PLANS

STATE OF NEW YORK
DEPARTMENT OF TRANSPORTATION
DESIGN AND CONSTRUCTION DIVISION
PLANS FOR CONSTRUCTING THE
EUCLID - NORTH SYRACUSE HIGHWAY

Field Change Sheets:
3F1, 5F1, 53F1, 12F1, 13F1, 13F2, 134F1, 135F1, 136F1, 137F1, 138F1, 139F1, 100F1, 101F1, 102F1, 103F1, 104F1, 105F1, 106F1, 108F1, 117F1, 119F1

As Built Revisions by Francis H. Backus
Approved: Eugene Parous, Asst. Contr. Supervisor, 3-27-1973
P.E. License No. 37013

PHOENIX-SYRACUSE S.H. 5274
 EUCLID-NORTH SYRACUSE S.H. 69-5
 BALDWINVILLE-CICERO S.H. 1039

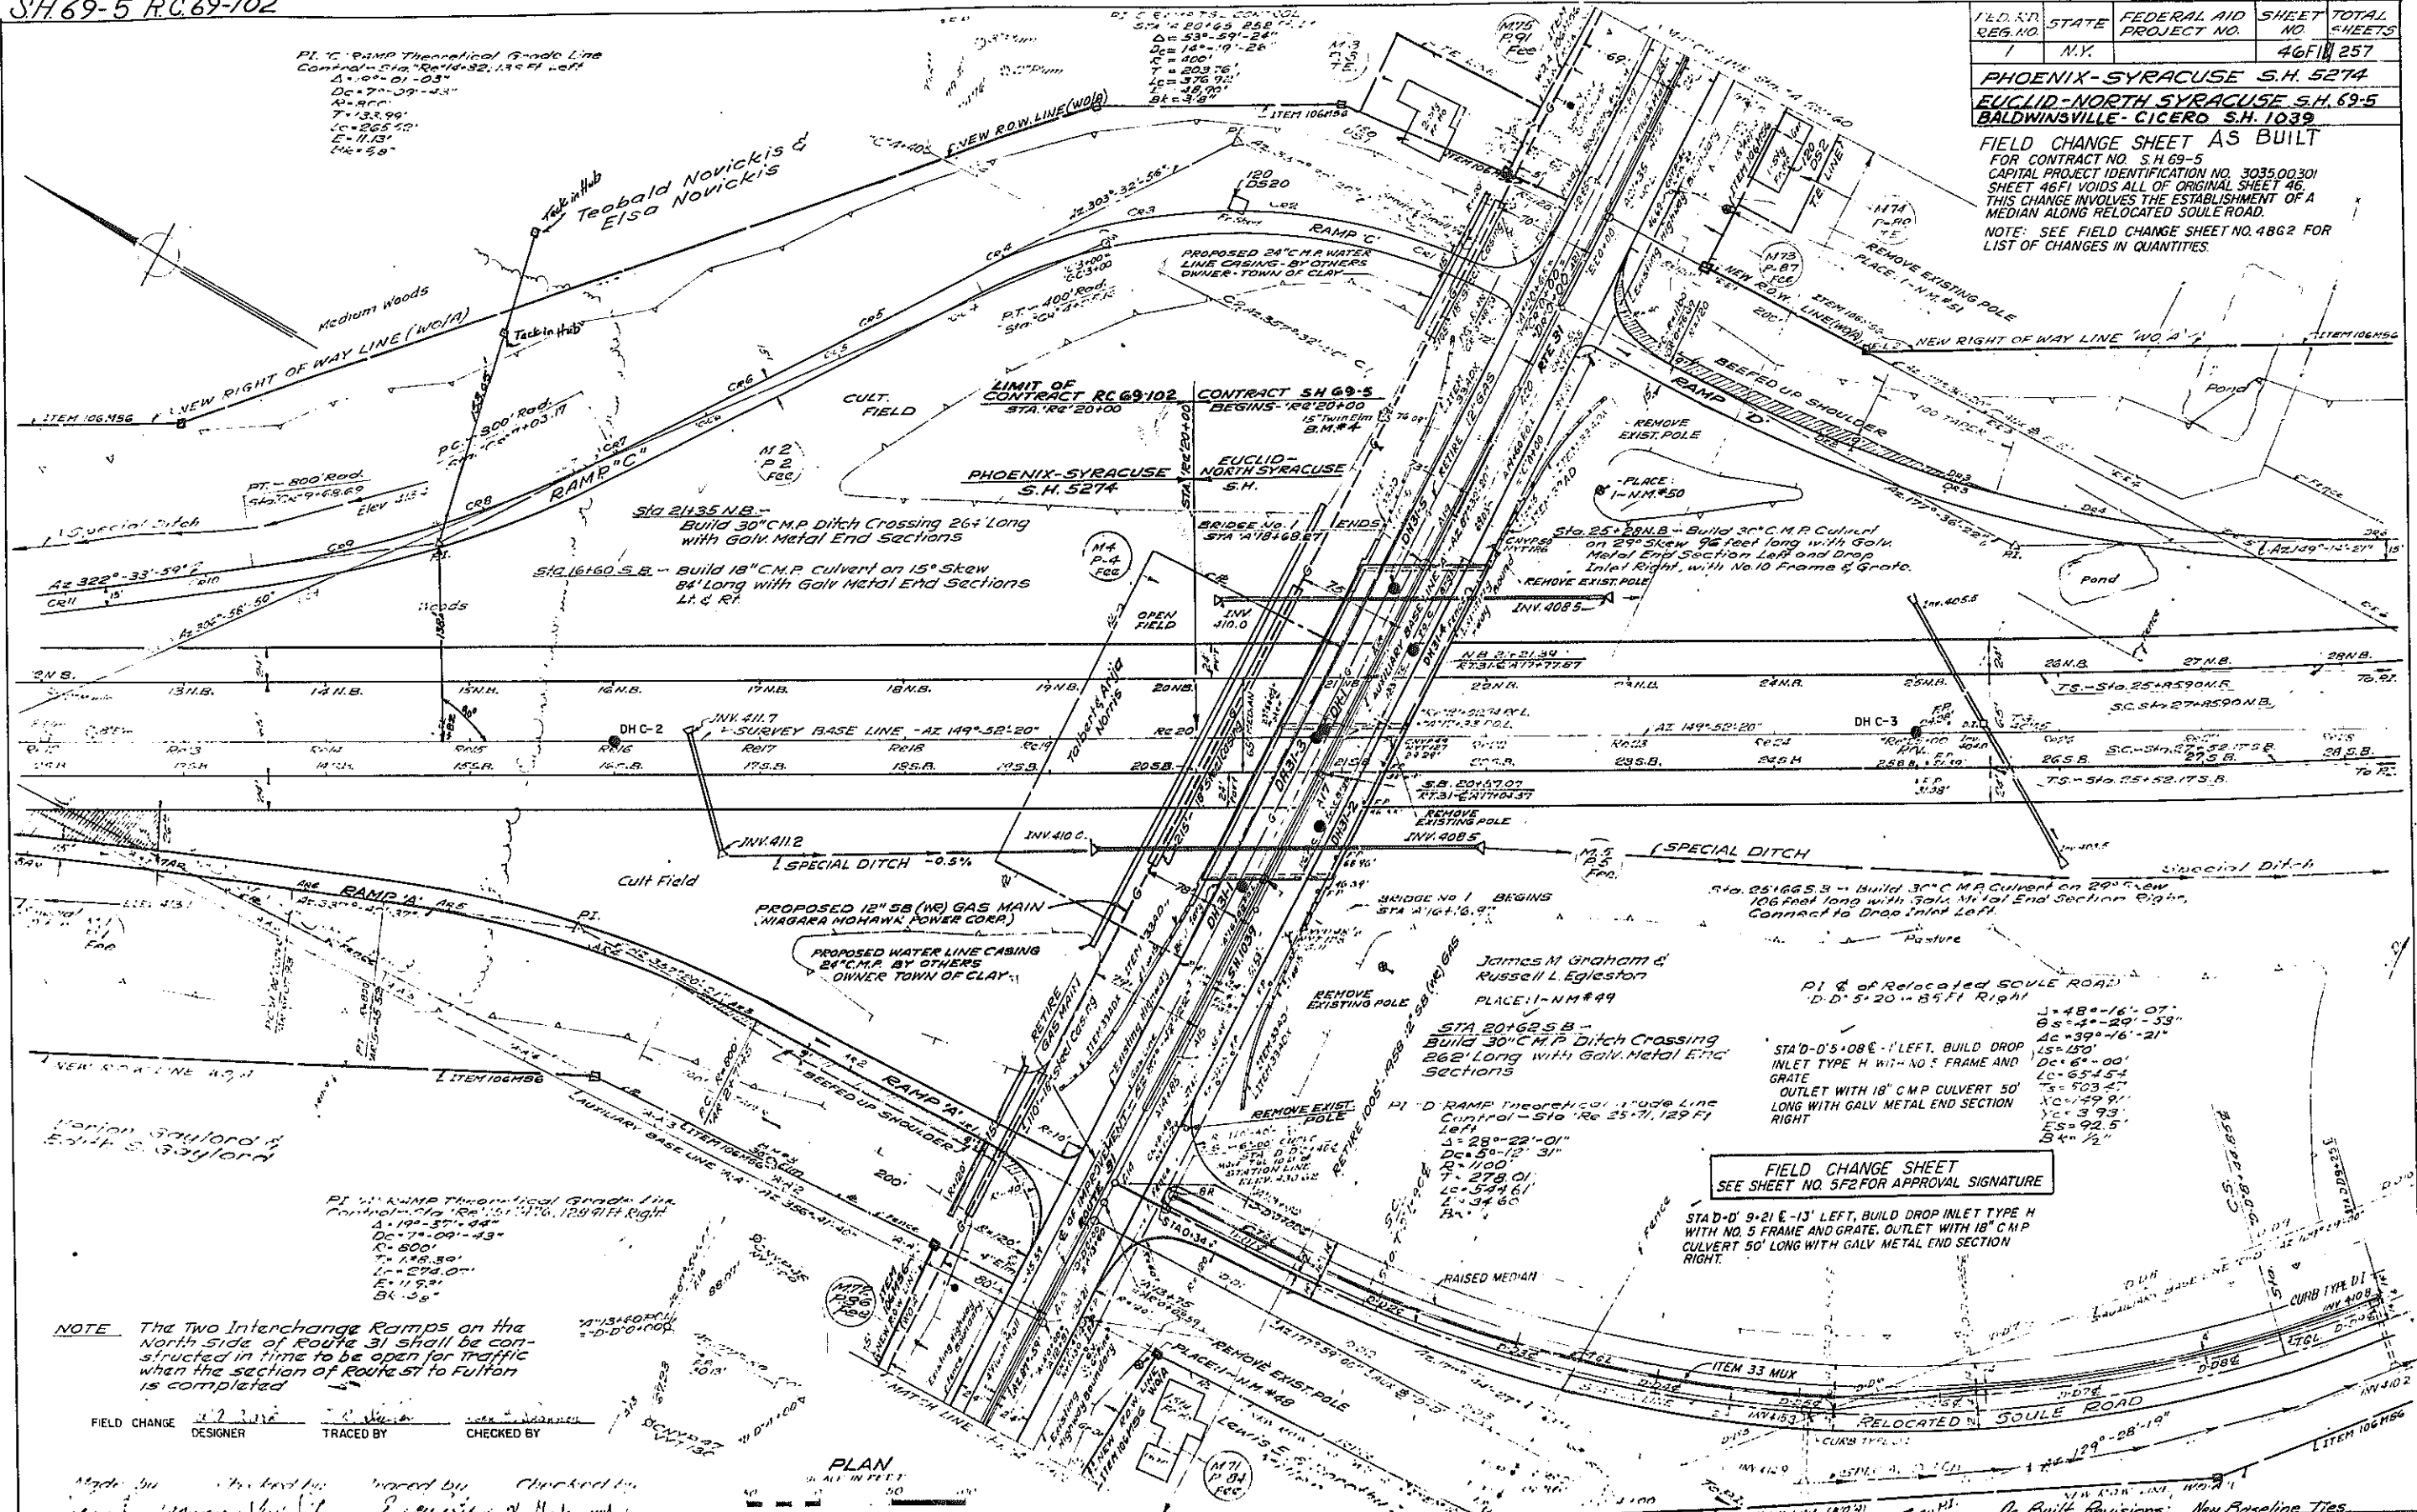
FIELD CHANGE SHEET AS BUILT
 FOR CONTRACT NO. S.H. 69-5
 CAPITAL PROJECT IDENTIFICATION NO. 3035.00.301
 SHEET 46F1 VOIDS ALL OF ORIGINAL SHEET 46.
 THIS CHANGE INVOLVES THE ESTABLISHMENT OF A MEDIAN ALONG RELOCATED SOULE ROAD.
 NOTE: SEE FIELD CHANGE SHEET NO. 4862 FOR LIST OF CHANGES IN QUANTITIES.

FIELD CHANGE SHEET

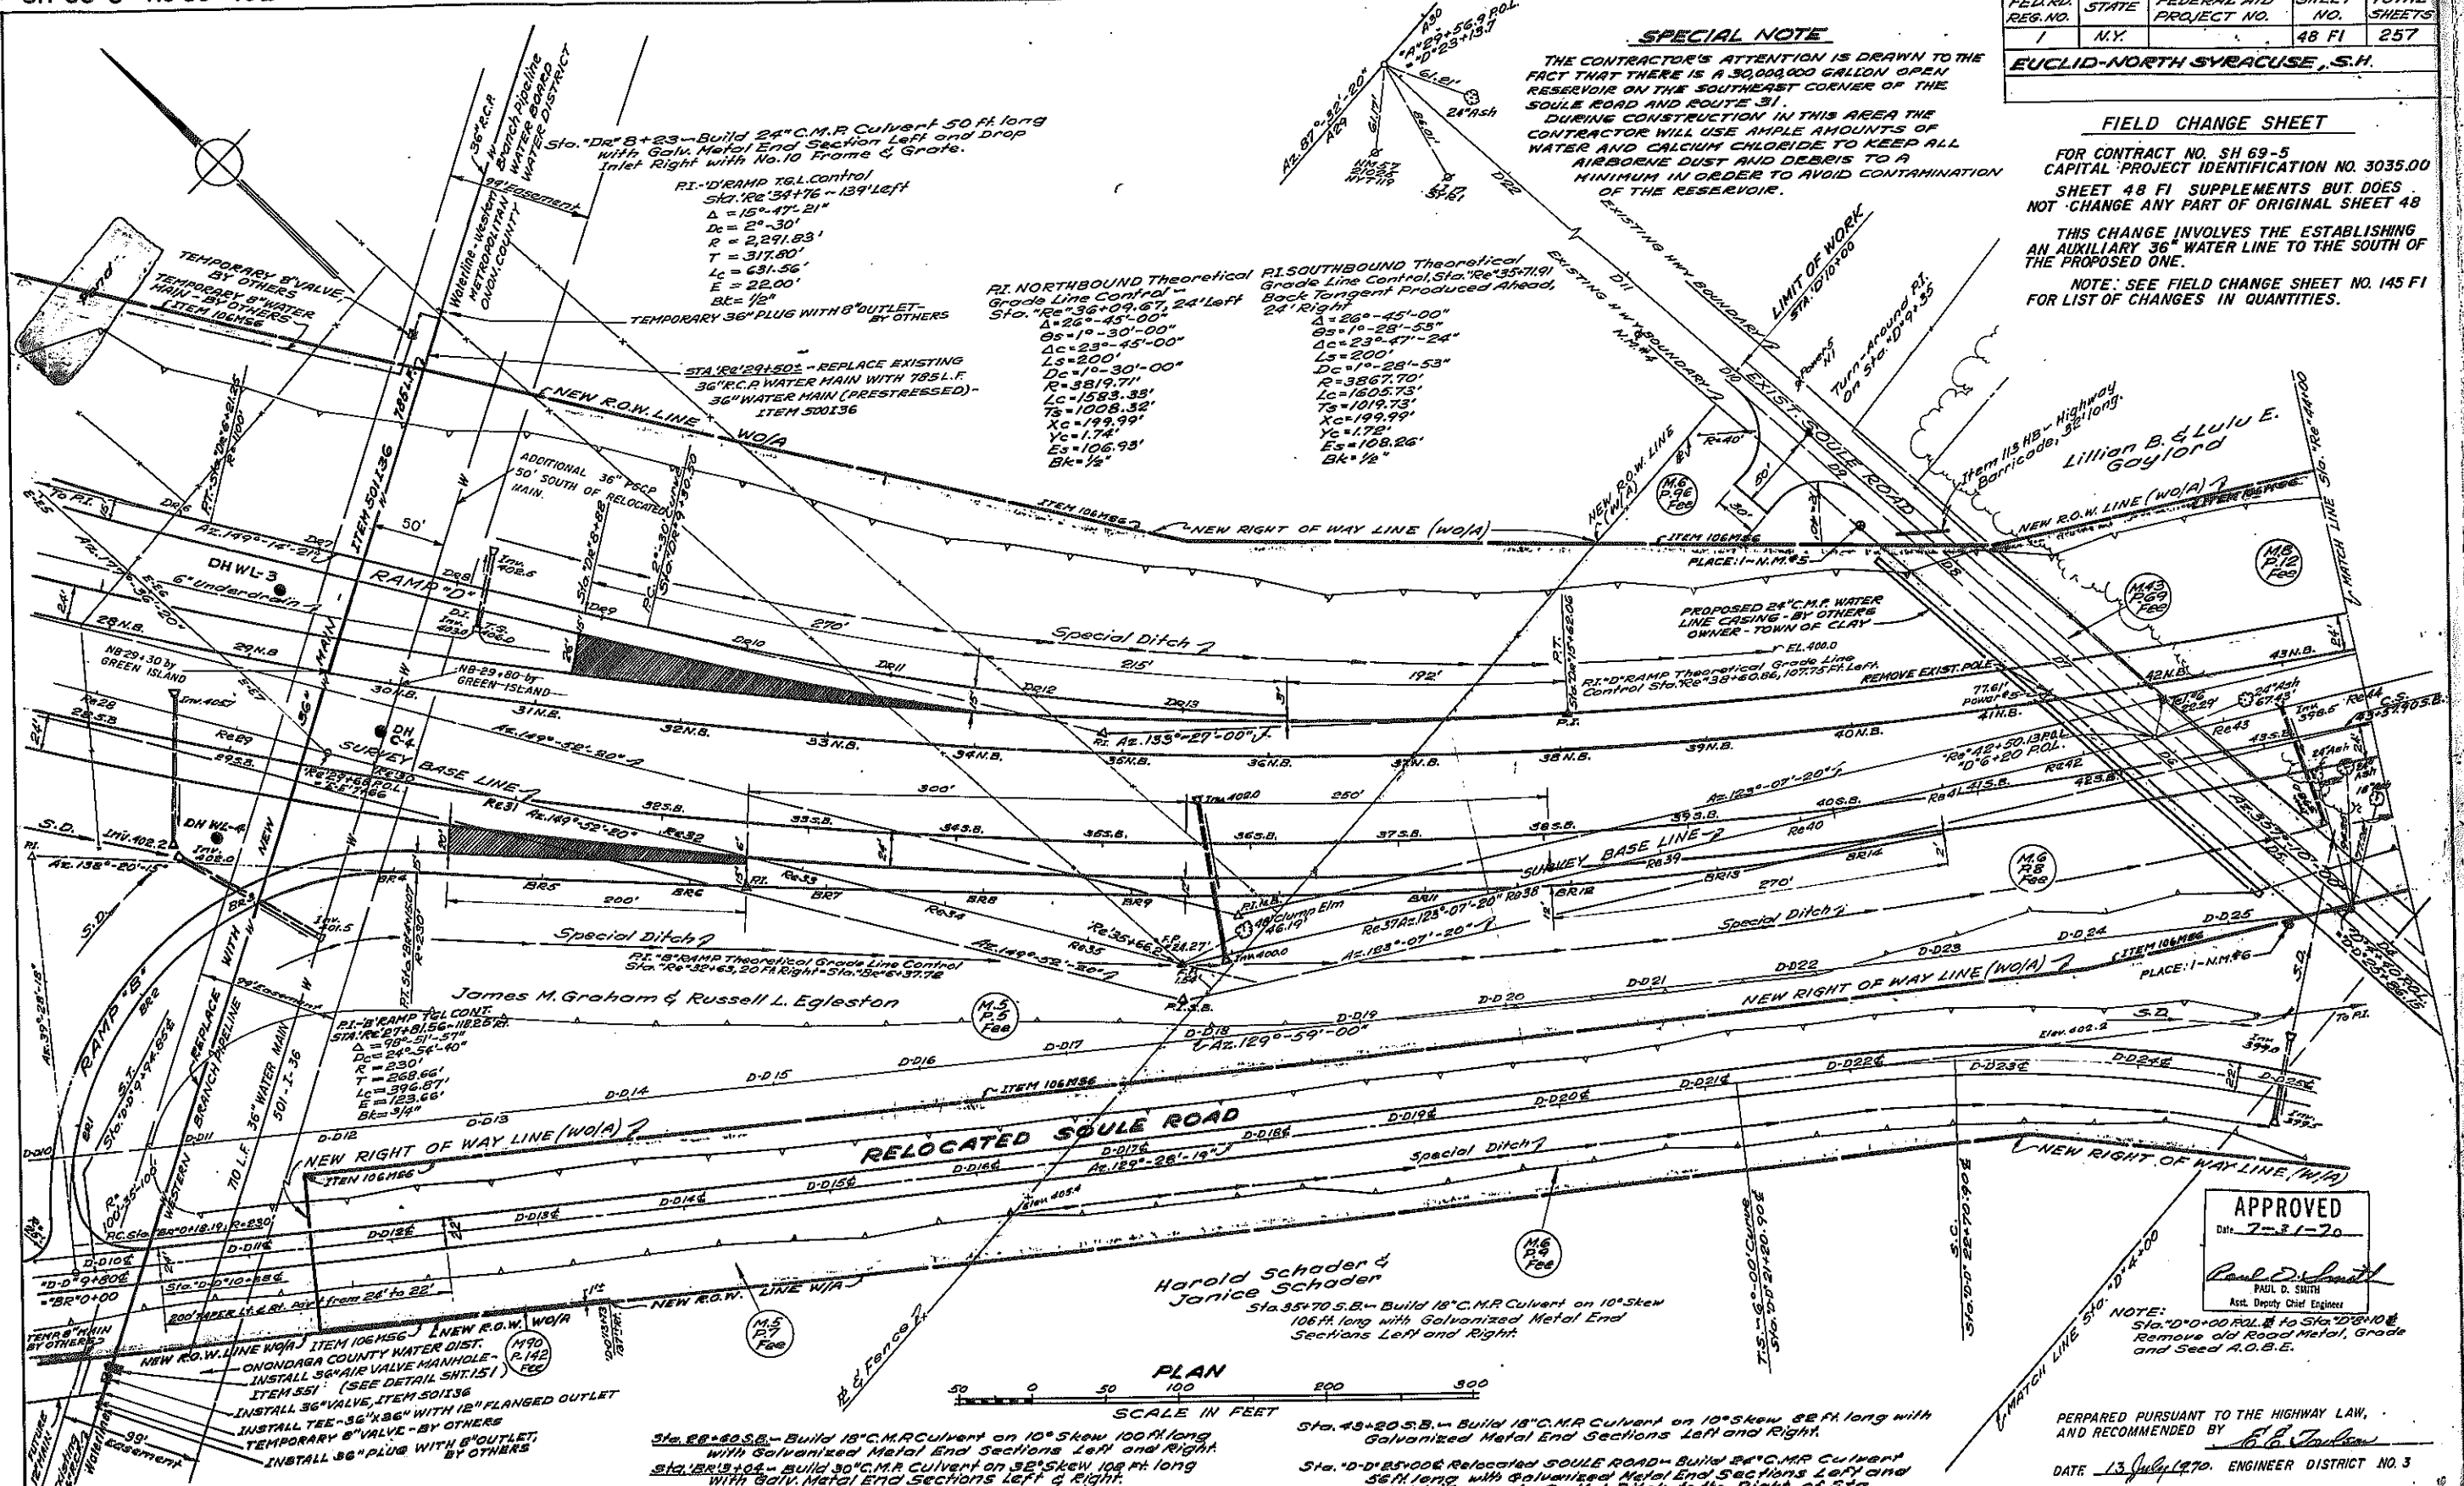
FOR CONTRACT NO. SH 69-5
CAPITAL PROJECT IDENTIFICATION NO. 3035.00
SHEET 48 FI SUPPLEMENTS BUT DOES NOT CHANGE ANY PART OF ORIGINAL SHEET 48

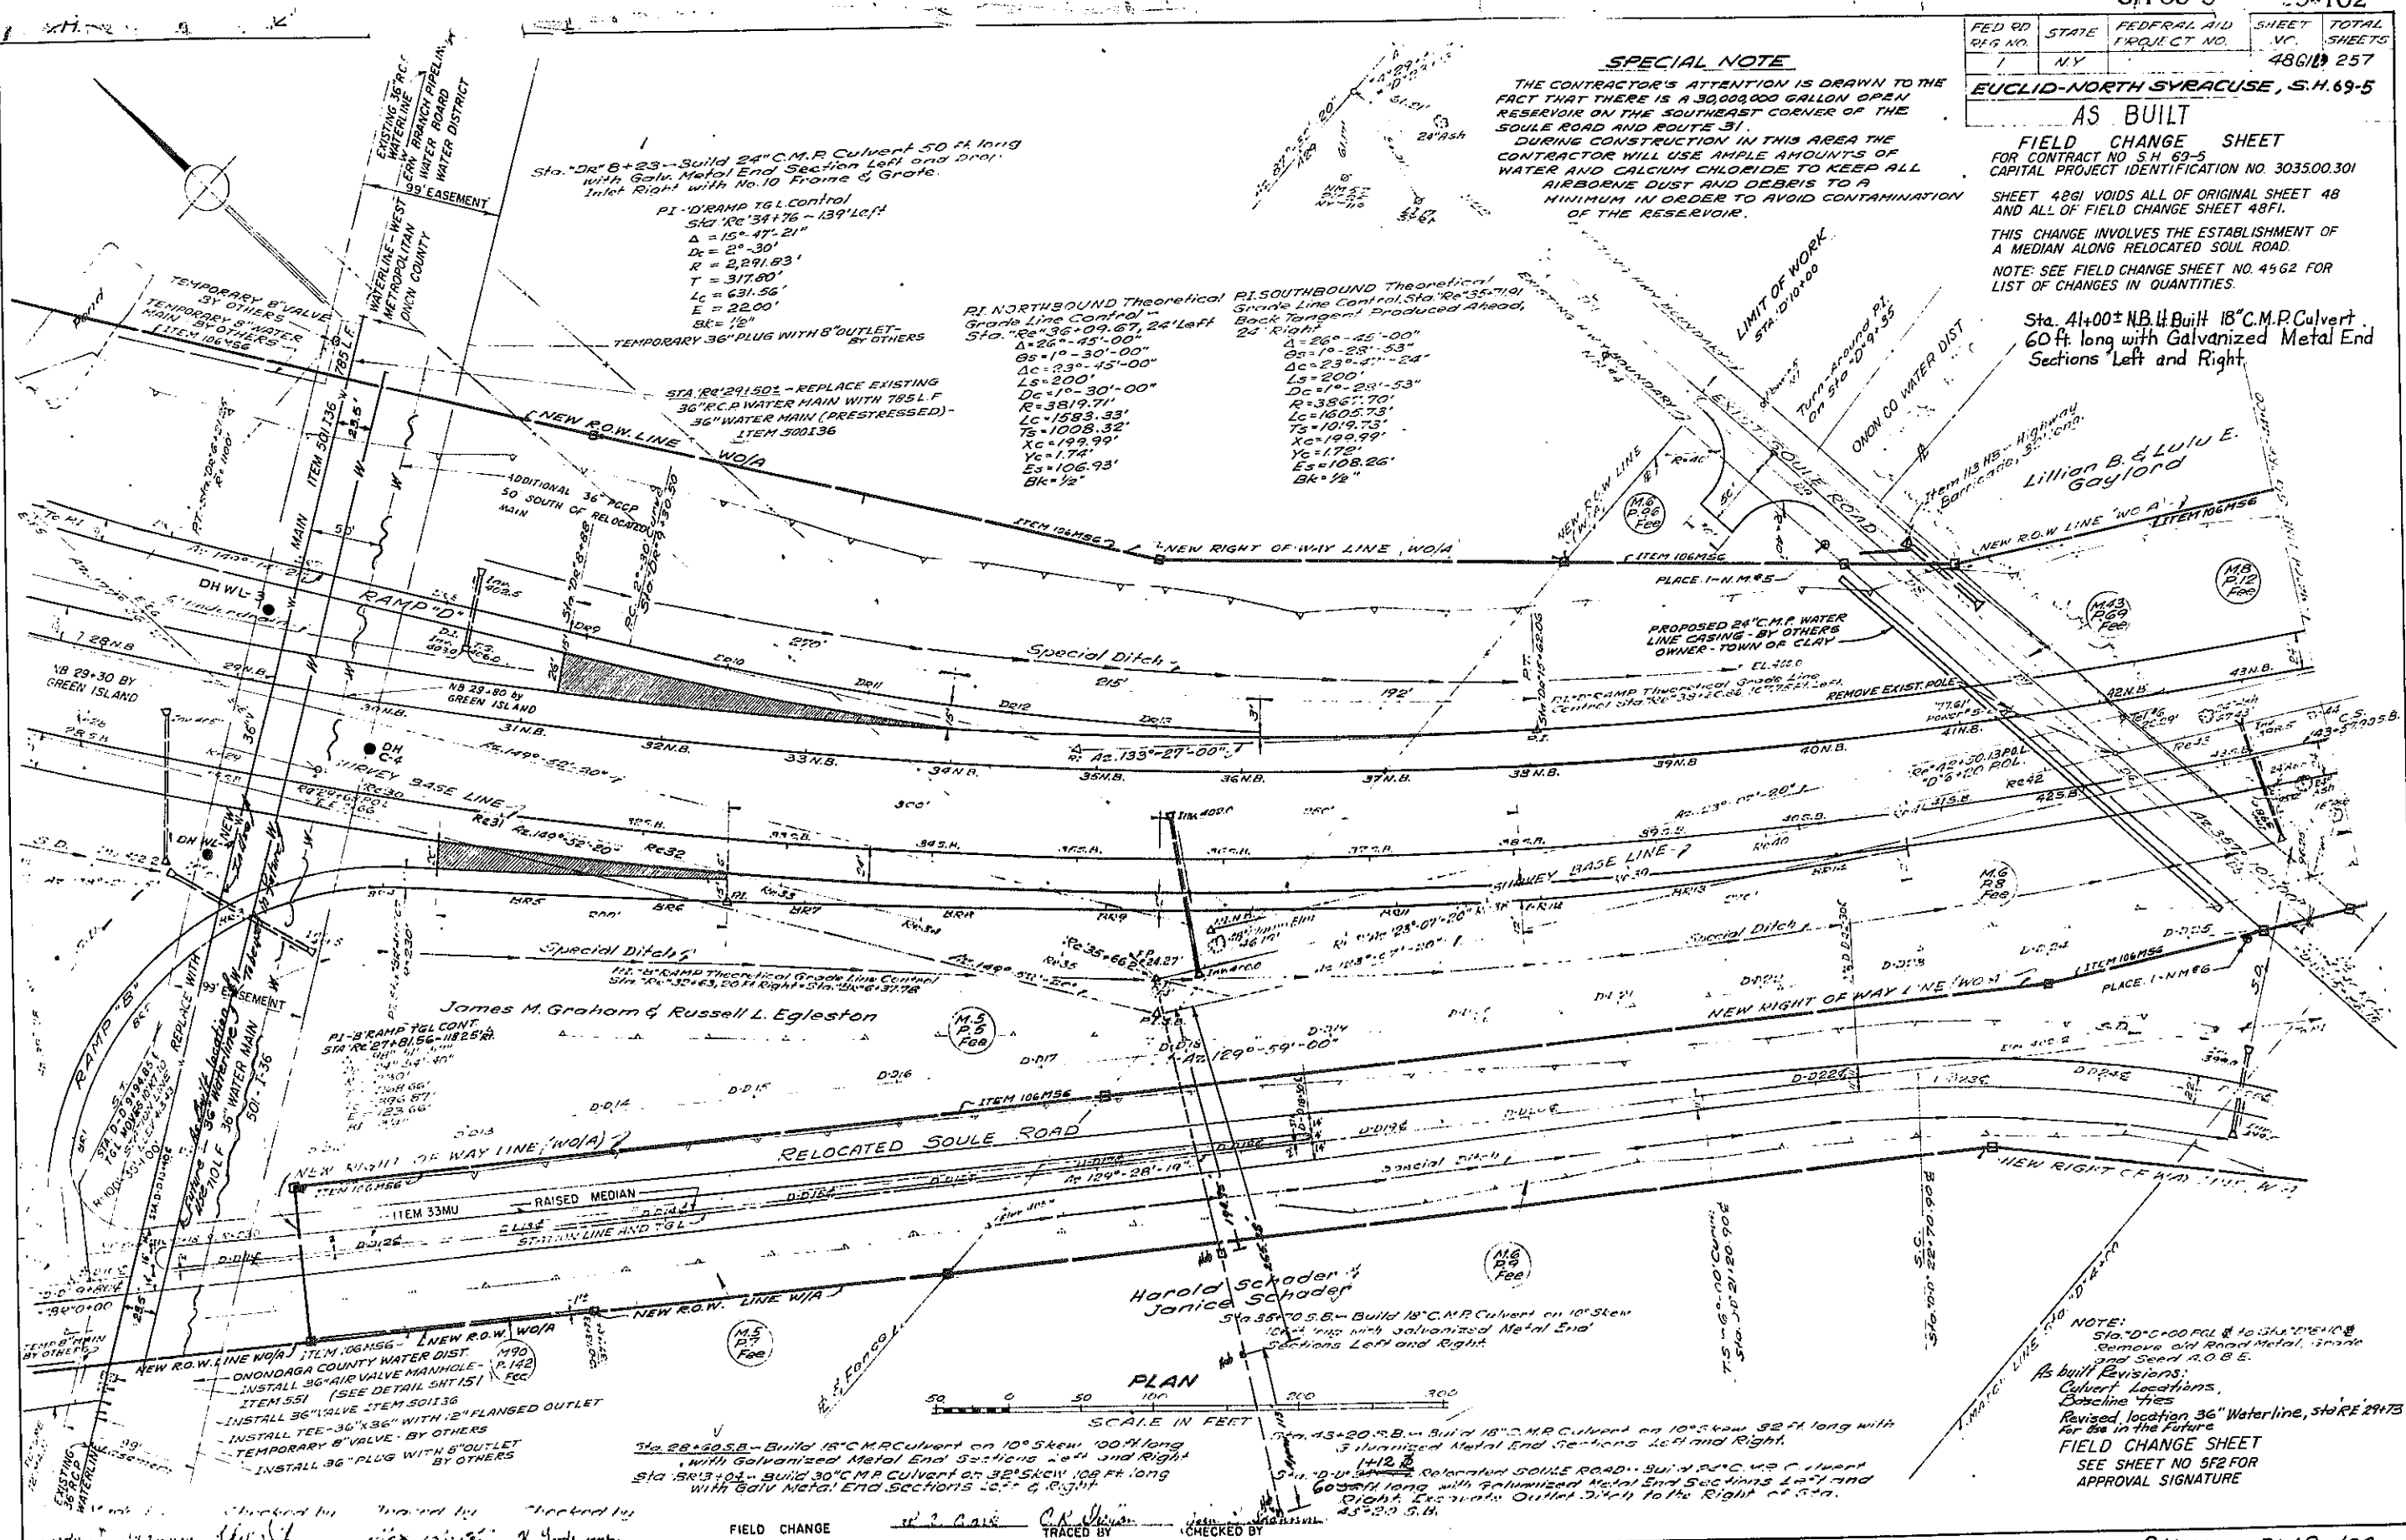
FIELD CHANGE SHEET
FOR CONTRACT NO. S.H. 69-5
CAPITAL PROJECT IDENTIFICATION NO. 3035.00.301
SHEET 486I VOIDS ALL OF ORIGINAL SHEET 48 AND ALL OF FIELD CHANGE SHEET 48F1.
THIS CHANGE INVOLVES THE ESTABLISHMENT OF A MEDIAN ALONG RELOCATED SOUL ROAD.
NOTE: SEE FIELD CHANGE SHEET NO. 4962 FOR LIST OF CHANGES IN QUANTITIES.
